TECHNICAL SERVICE BULLETIN

Bulletin Number: S-07-05A

SUBJECT: 2007 Canadian / International 700 CFI Dragon ECU Reflash / Thermostat Update

Reflash:

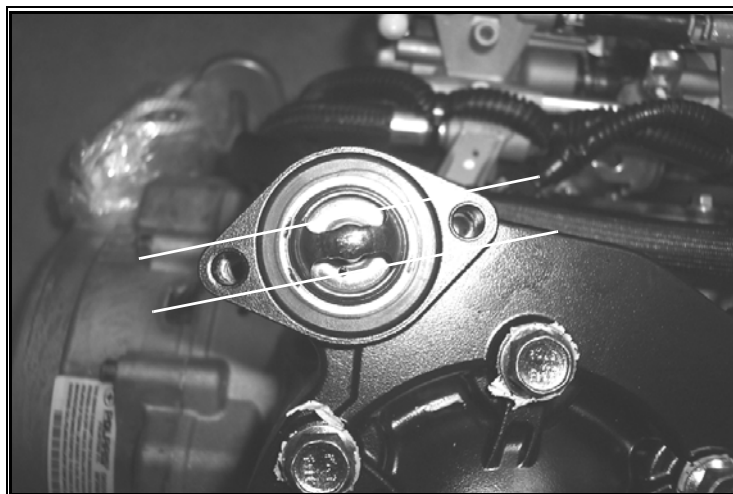
Polaris has received reports from the field regarding spark plug fouling and poor engine performance throughout the powerband on some 2007 700 CFI Dragon snowmobiles.

To resolve these concerns, Polaris has released new ECU calibration files and developed a new heavy duty thermostat. The original thermostat may break when open. Once broken, the thermostat cannot close and the cooling system will over-cool the engine.

Please follow the instructions outlined within this Service Bulletin and reflash the ECU to new ECU calibration file and install the new heavy duty thermostat.

1. The new 2007 700 CFI calibration part numbers are:
 - 4011995 - RED INJECTORS
 - 4011996 - BLUE INJECTORS
 - 4011997 - YELLOW INJECTORS
2. Verify the color of the fuel injectors installed on each engine. The color can be seen on the ECU decal or on each of the fuel injectors's protective sheaths.
3. Follow the Digital Wrench software guide (pages 11.43 - 11.46) in the 2007 Two-Stroke Service Manual, PN 9920463.

4. Download and install Version 3.0 Update: PDW_3_00_030207_Intl.exe. Once the update is installed, the new files will be available for the reflash procedure.
